PARTS & SERVICE NEWS

REF NO.	AA04093
DATE	June 22, 2004

SUBJECT: AUTO LUBE PUMP ADJUSTMENT

PURPOSE: To introduce fixed pressure and flow valves that will eliminate incorrect adjustment of auto lube pump.

FIGURE 1. FIXED VALVES

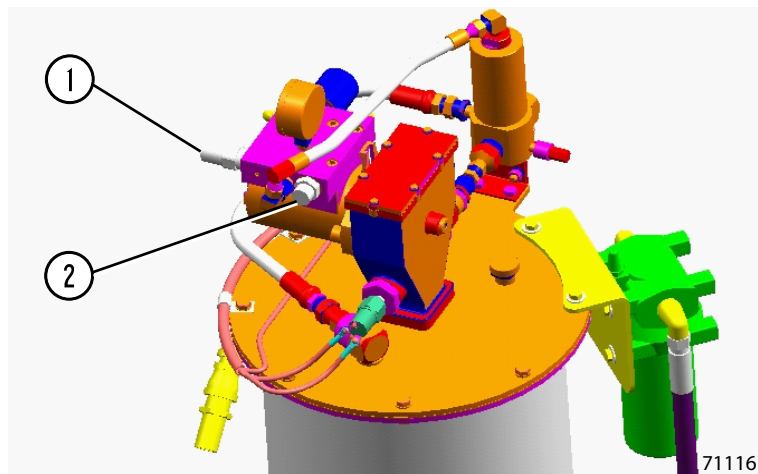
Currently, the auto lube pump has adjustments for both pressure and flow. Some electric drive trucks in the field may have had pumps incorrectly adjusted for pressure and/or flow. Improperly adjusted lube pumps may lead to one of the following:

- Over pressurization
- Pump too fast causing warning light problem
- Pump too fast causing accelerated pump wear
- Pump too fast causing cavitation

Komatsu has introduced fixed valve assemblies to eliminate incorrect adjustments of the auto lube pump. A constant pressure and flow may be obtained by installing pressure control valve (PC1770) and flow control valve (PC1769) to the auto lube system. Figure 1 illustrates the location of each fixed valve.

NOTE: The pressure control for pump assemblies (PC0810, PC0821, and PC1149) is set from 350 - 400 PSI and flow control is set at 2 gallons per minute. This means that the pump should take from 16 - 18 seconds to build full pressure.

1. Pressure Control Valve (PC1770)
2. Flow Control Valve (PC1769)
